HISTORIC AND DESIGN REVIEW COMMISSION

May 17, 2017

HDRC CASE NO: 2017-207
ADDRESS: 325 W MISTLETOE
LEGAL DESCRIPTION: NCB 1834 BLK 9 LOT 16
ZONING: R-4 H
CITY COUNCIL DIST.: 1
DISTRICT: Monte Vista Historic District
APPLICANT: Tyler Sibley/Pursuant Ventures
OWNER: Tyler Sibley/Pursuant Ventures
TYPE OF WORK: Fenestration modifications
REQUEST:

The applicant is requesting a Certificate of Appropriateness for approval to remove and replace an original 6 over 1 window on the primary façade with a new 1 over 1 window.

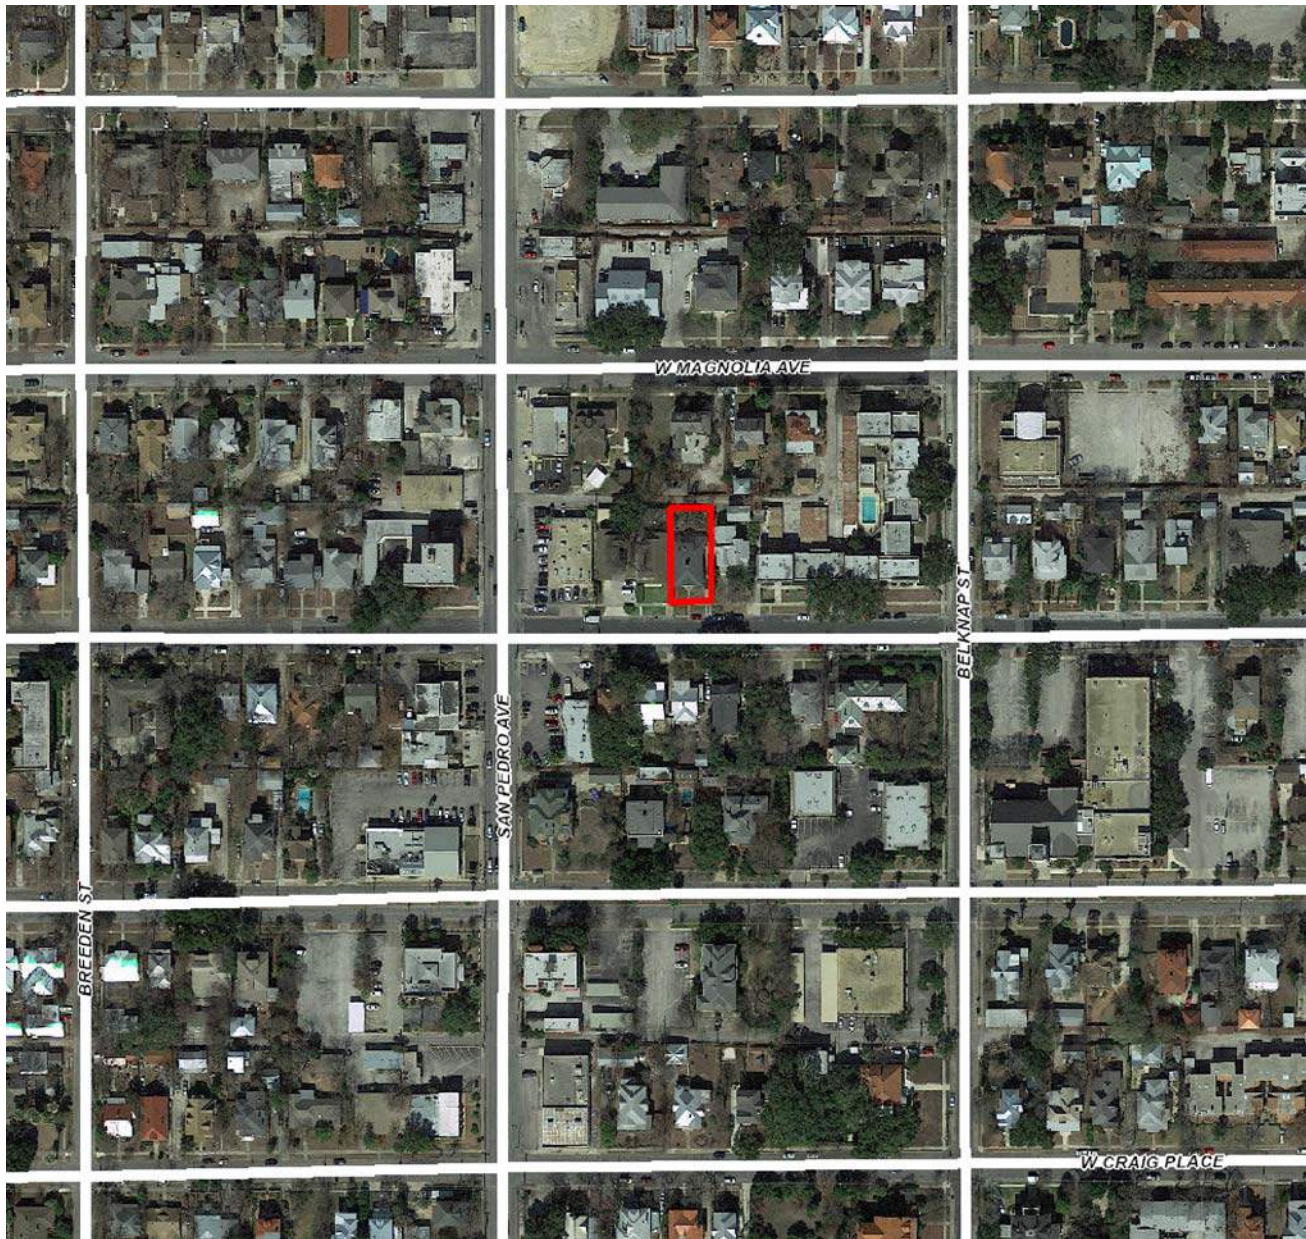
- b. WINDOW REMOVAL – The original 6 over 1 window, located directly to the right of the property's main entrance, has been removed and replaced without approval. Administrative approval was granted to repair the original window on August 12, 2016. According to the Guidelines for Exterior Maintenance and Alterations, historic windows should be preserved unless deteriorated beyond repair. The proposed removal and reuse of the 6 over 1 window is not appropriate.

- c. HISTORIC TAX CREDIT VERIFICATION – The window was previously deemed repairable when approved for Historic Tax Credit Certification on December 7, 2016. The property is currently in violation for requirements for final Historic Tax Credit Verification and is not eligible for the incentive unless the original window or a salvaged 6 over 1 window is returned in place of the new window.

Staff does not recommend approval of the window removal based on findings a through c.
